DRAFT MINUTES

This is a Hearing under Section 28 (12) of the *Conservation Authorities Act*, R.S.O. 1990, as amended, concerning an application made pursuant to Ontario Regulation 174/06.

- The application is: **RV6-0622 and RV6-4723**
- The properties are located at **Lot 28, Concession 1, geographic township of Rideau, now the City of Ottawa. Known municipally**

Subject: Revised application for development to Ontario Regulation 174/06 under Section 28 of the Conservation Authorities Act at 6981 Fennell Lane, Lot 28, Concession 1, Former Municipality of North Gower, now the City of Ottawa. Roll#: 0614 1828 2523 0000 0000

DECK SITE PLAN

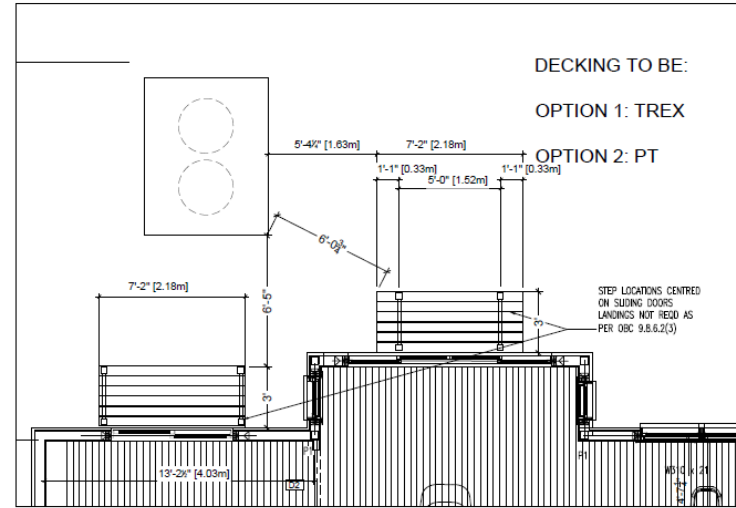
- Construction of a covered porch. The wrap around porch roof was previously approved by the City as per stamped plans, Stamp date August 4, 2022. The porch decking follows the porch roofline to allow for use of the cover above. Without the porch decking, we are left with a sheltered area we cannot realistically make use of. We are retired and in our late sixties so it is very natural to desire to be able to enjoy the shelter provided by the porch roof. We picture sitting on it in the evening or morning to simply enjoy the rural nature of the setting. As such, we are submitting for a building permit to allow for use of this decking under such welcoming shade/shelter. It was advised however, that RVCA approval of this is required prior to the City providing building permit approval.

- The approved plans limit the lower level height to 5'-11" as a result of the committee of adjustment decision file no. O08-02-21/A-00435. Current construction of the lower level appears to not be in conformance with the aforementioned. The height limitation on this space is explained by RVCA as intentional to limit the area as an unused crawl space to allow possible flood waters to pass through in and out of the crawl space through the foundation windows. We were told that because of this, all mechanical would need to be suspended under the floor above to prevent flood damage to it.

Site Photo: (taken by E. Lalande Oct 12, 2023) showing basement

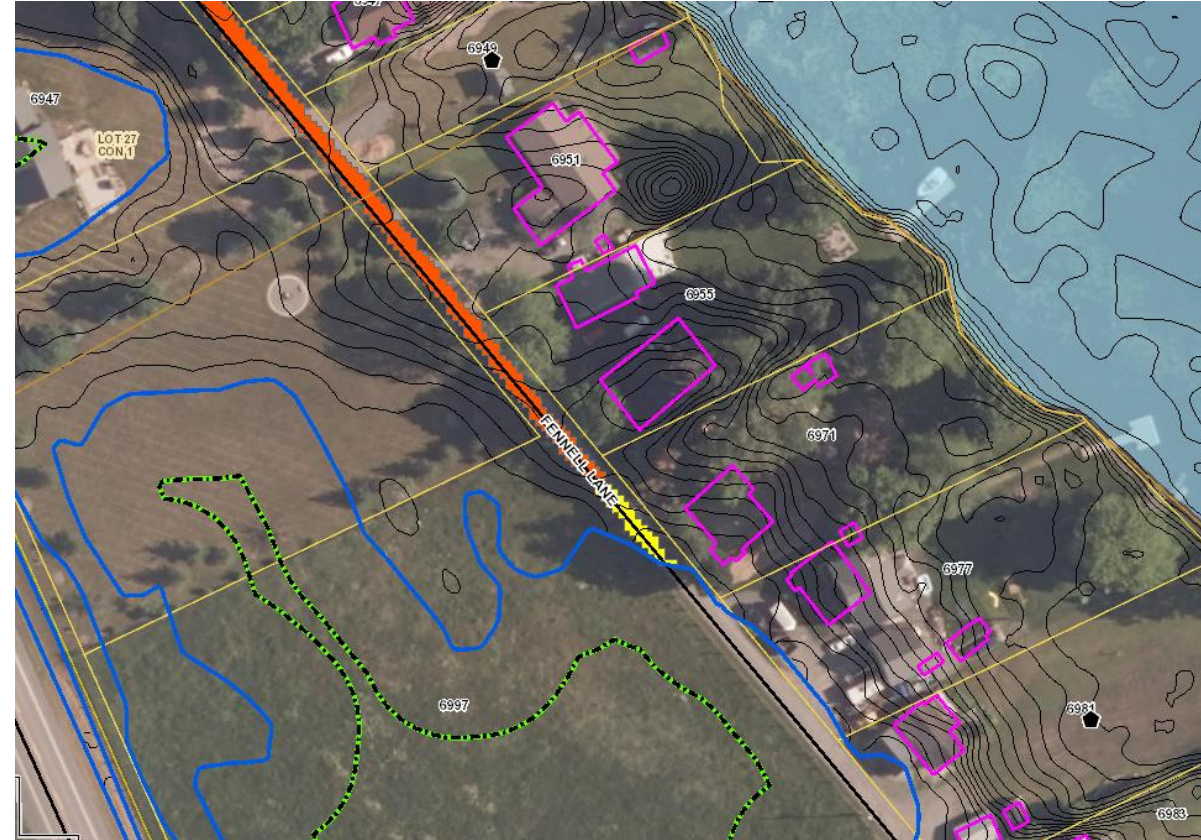
There is insufficient information for RVCA staff to comment on floodproofing measures proposed by revised design. The current submission would be considered as wet floodproofed full height basement which is prohibited by policies.

Updated Survey (Nov 2023)

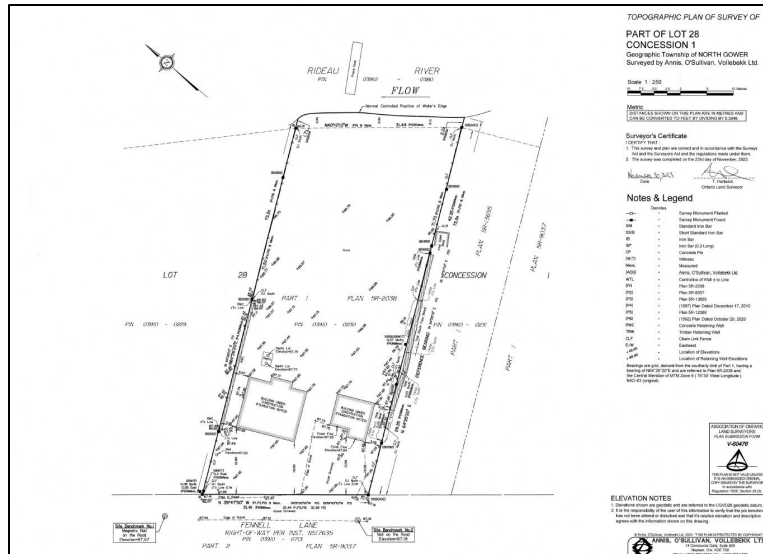
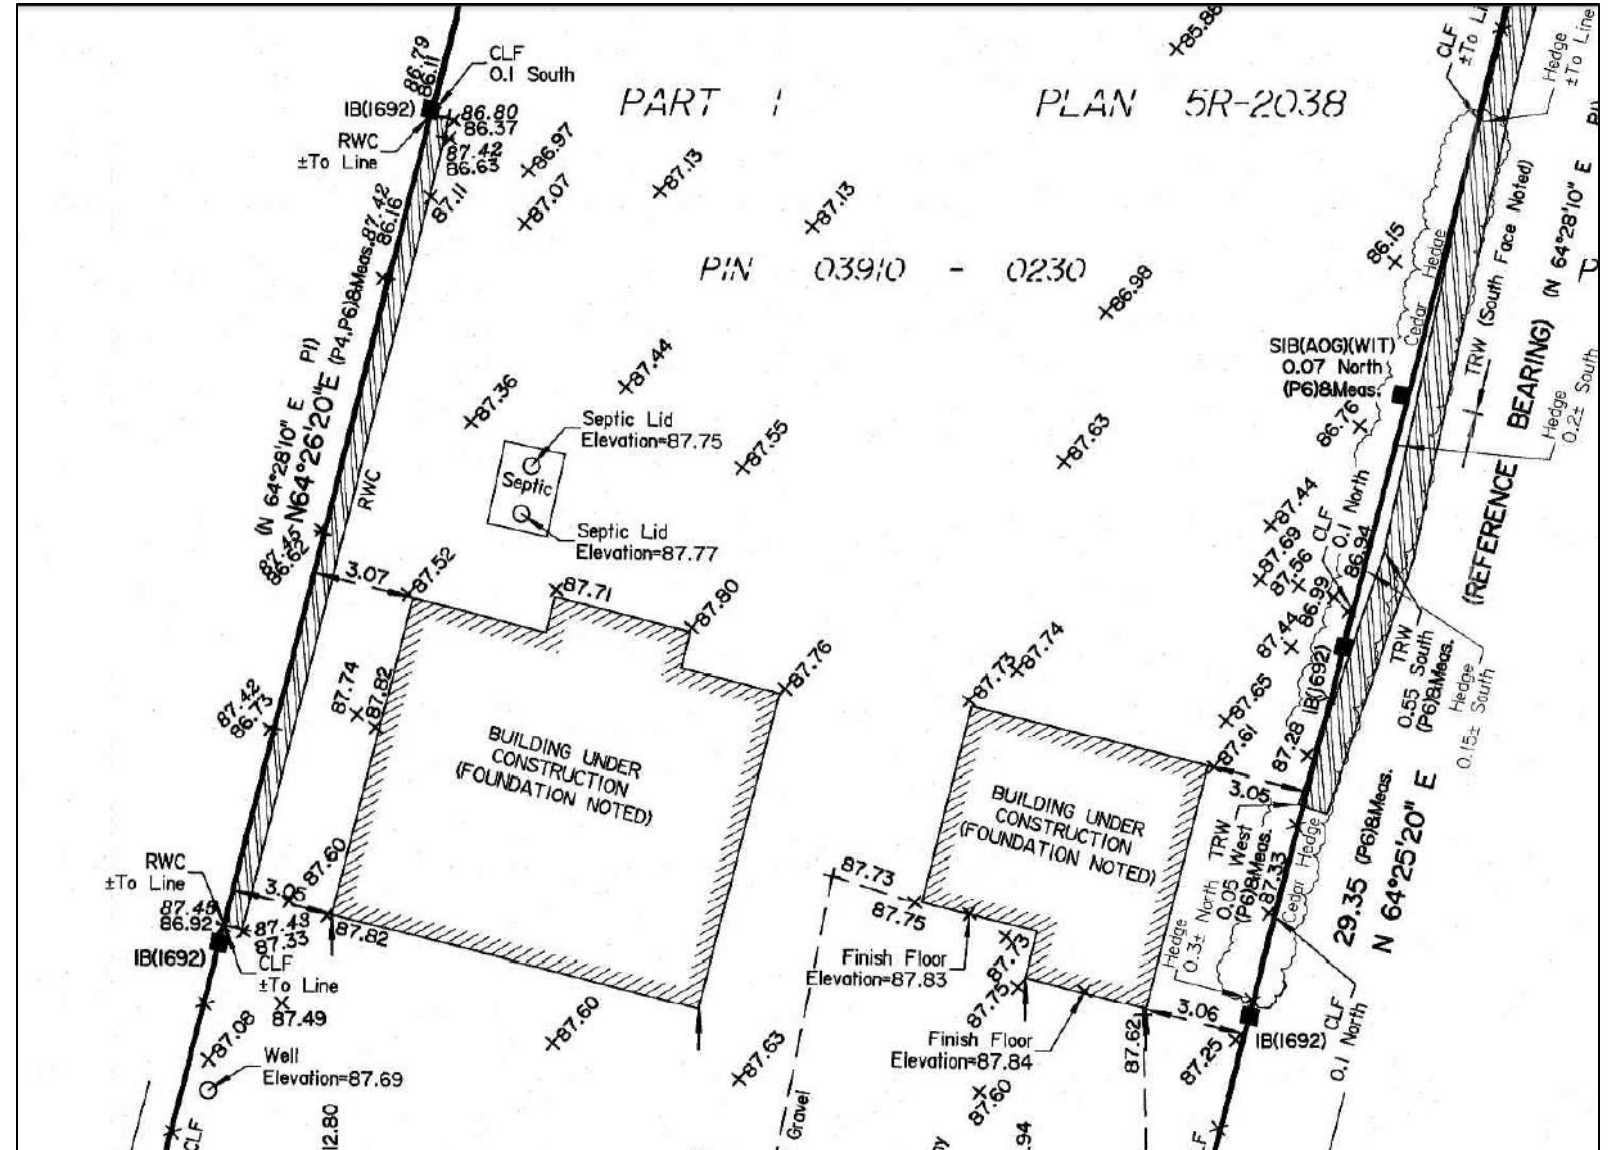
Mr. Lalande provided information regarding the approved fill plans in comparison to the ongoing construction work, highlighting discrepancies. He noted that an unquantified volume of fill has been placed on the property, surpassing the grading work approved by the original application. While the original grading plan was prepared by a qualified professional, the requested changes to the grading have not been presented or analyzed by RVCA policies.

Furthermore, the proposed fill does not account for any offsetting removal of fill and exceeds the depths outlined in the policies. Consequently, the policies cannot be met without significant alterations to the design, which may not be feasible given the proposed development's location within the floodplain. Therefore, it has not been demonstrated that the work requested as part of the revised application will result in no negative impacts on the floodplain.

An unquantified volume of fill has been placed on the property in excess of the grading work as approved by the original application. While the original approved grading plan was prepared by a qualified professional, the requested changes to the grading have not, nor have they been

- As related to placement of fill and associated grading work, to complete a professional analysis and appropriate mitigation measures as required by RVCA policy.

BASEMENT HEIGHT COMPARISON

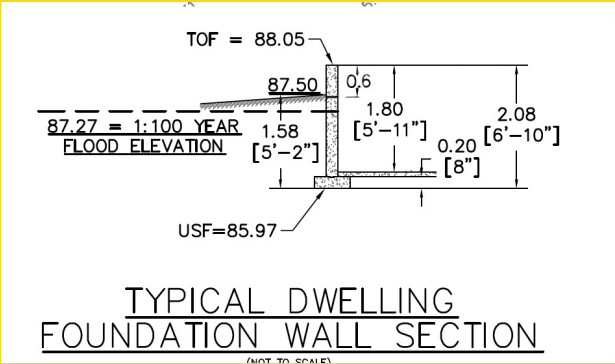
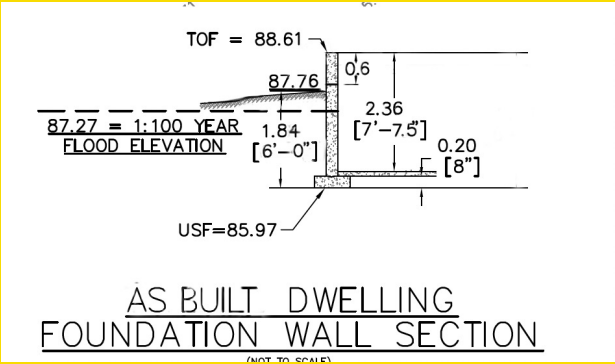
Mr. Long proceeded to present details regarding the proposed construction at 6981 Fennell Lane, focusing on the addition of a 7'7 1/2" unfinished basement. Mr. Long clarified that the underside of the basement would remain unaltered and that the construction had been certified by surveyors and permitted by the City of Ottawa. He referenced Article 1.1.3, Type 1 extension of the basement, disputing claims that this extension had been implemented. Mr. Long emphasized that the basement area was intended solely for storage, accessible only through a trapdoor hatch, and measures had been taken to mitigate potential flood damage by elevating belongings. Despite the original permit allowing for a basement height of 5'11", Mr. Long expressed concerns about the strain on the owner and the lack of accessibility features in the original plan. He contested RVCA's assertion that a full-height basement had been constructed, arguing that the space would not be used as living quarters. Mr. Long detailed additional measures implemented, such as a double sump pump system, water alarm system, and emergency backup generator, to support the intended use of the basement for storage. He also provided information on the construction methods employed. Ultimately, Mr. Long requested approval to retain the current configuration of the lower level, considering accessibility challenges and the intended use solely for storage purposes.

Anne Barr directed a question to the applicant regarding the decisions made to build the basement higher and add a second floor. Mr. Long responded, clarifying that the second floor was a mezzanine level, which was not intended for habitation but rather as a design feature that had been approved. Ms. Barr then inquired about the decision-making process regarding the increase in basement height. Mr. Long explained that they had made the decision independently, as the originally planned height of 5'11" did not meet their needs.

- With respect to the construction of a full height basement for an additional gross floor area of 115.92 m² (1237.85 ft²); with reference to page 7 of the Hearing package with respect to RVCA policies detailing the requirements for section 1.4.2 (d) Dry Flood Proofing (Full Basement) the following need to be met;

- *underside of main floor shall be at least 300 mm. above the 1:100 year flood level;*
 - *structural details of foundation elements and specifications for fill materials and compaction procedures must be prepared or approved by a qualified Professional Engineer at the applicant's expense;*

CONSTRUCTION OF COVERED PORCH FOR APPROVAL

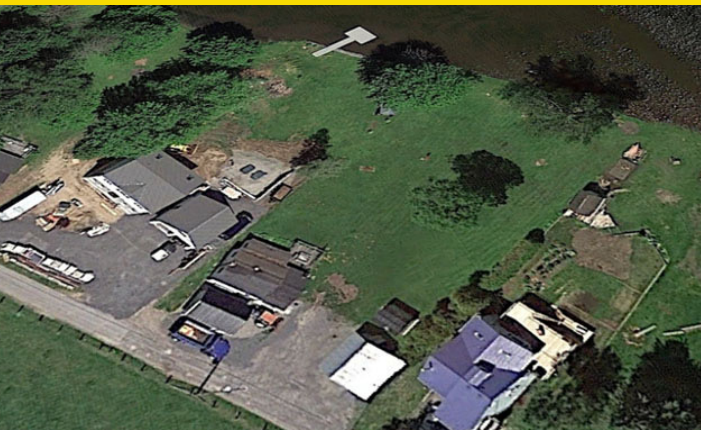
The presentation addresses the covered porch and further emphasized the necessity of safe passage between the doors without the requirement to navigate stairs. Mr. Long referred to the approved plans by the City of Ottawa, which included provisions for covered porch plans, originally conceived as a deck to address this need. He highlighted Article 1.3.3 of the RVCA regulations, which permitted only a 7.3 square meter increase, as depicted in accompanying photos. Additionally, he drew attention to Section 1.3.3, Article 3, which addressed additional peripheral concerns, particularly focusing on the RVCA's limitation on roof overhang to less than 10%. Mr. Long questioned the rationale behind this policy, citing the absence of supporting justification. He pointed out inconsistencies, noting neighbouring decks that were fully covered and enclosed, questioning why such restrictions were imposed by the RVCA. He further argued that these neighbouring decks were constructed in 2014, long after the policies were enacted in the 1990s, suggesting that a precedent had already been established by the actions of neighbouring property owners.

- porch roof was approved on stamped permit drawings dated August 4, 2022. permit no. 2206283
- deck below porch roof was built following roof line to connect the two entry doors for one level access thus limiting need to use stairs and for accessing windows for service/cleaning
- back deck was omitted to allow for front porch area of 27.13sqm (292 sqft)
- neighbouring decks appear larger than our requested 27.13 sqm
- neighbouring decks constructed after 2014, well after RVCA policies came into effect in early 1990's

**AS BUILT GRADING PLAN
- APPROVED BY CITY OF
OTTAWA 21/12/2023**

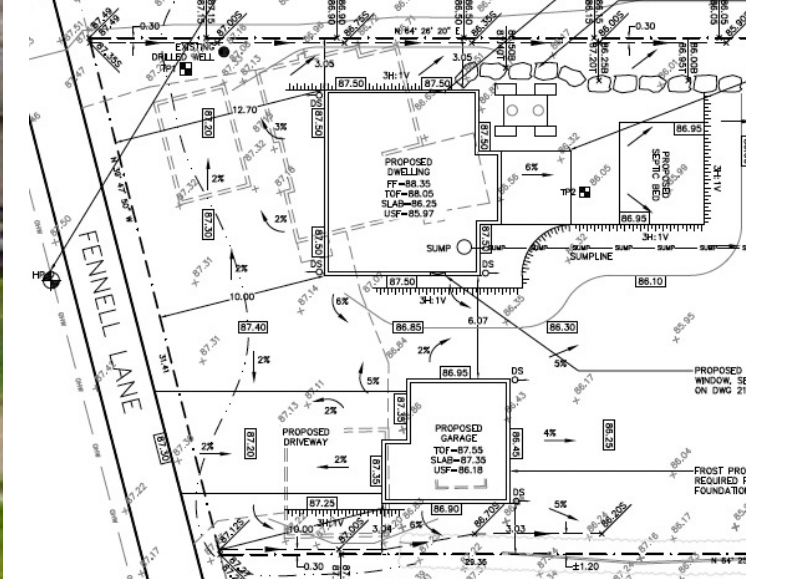
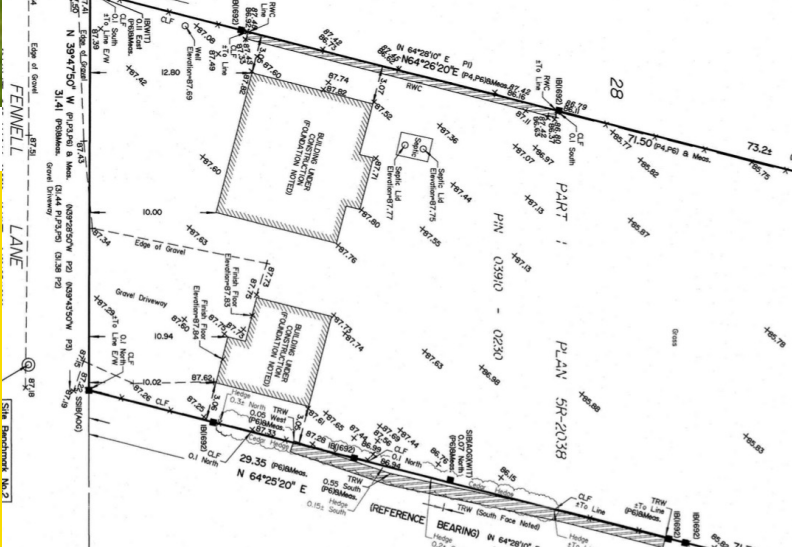
About the placement of fill, the presentation emphasized the necessity of a safe and gradual transition, contrasting it with the significant drop currently present. Mr. Long highlighted that the fill on the property is not as extensive as that on neighbouring properties, and in fact, is slightly lower in elevation. He stressed that this fill had been approved by the City of Ottawa and is essential for facilitating the safe transportation of lawn care equipment. The gradual slope provided by the fill promotes accessible terrain and mitigates the risk of injury. Mr. Long sought approval to formalize the grade currently in place, referencing the as-built grading plan approved by the City of Ottawa on December 21, 2023. He provided further details, explaining that the fill does not extend as far towards the river as on the two abutting properties and complements the existing grading on adjacent properties. Moreover, he emphasized that the grading of the fill allows for a smooth transition to the lower yard, ensuring safe passage for property maintenance equipment. Mr. Long highlighted the importance of accessibility, particularly considering the advanced age of the owners, and noted that the grading prevents potential liability issues and visitor injuries that may have arisen with the irregular slopes shown on the original grading plan.

- as built grading plan approved by city of Ottawa Dec 21, 2023
- fill does not extend as far towards river as on two abutting properties
- fill complements the existing grading on adjacent property and is indeed somewhat lower in elevation than abutting properties
- grading of fill allows smooth transition to lower yard for safe passage of property maintenance equipment
- fill ensures accessibility considering owners advanced age eliminating steep and irregular slopes shown on original grading plan
- grading prevents possible liability and visitor injury issues that may have been encountered with irregular slopes shown on original grading plan
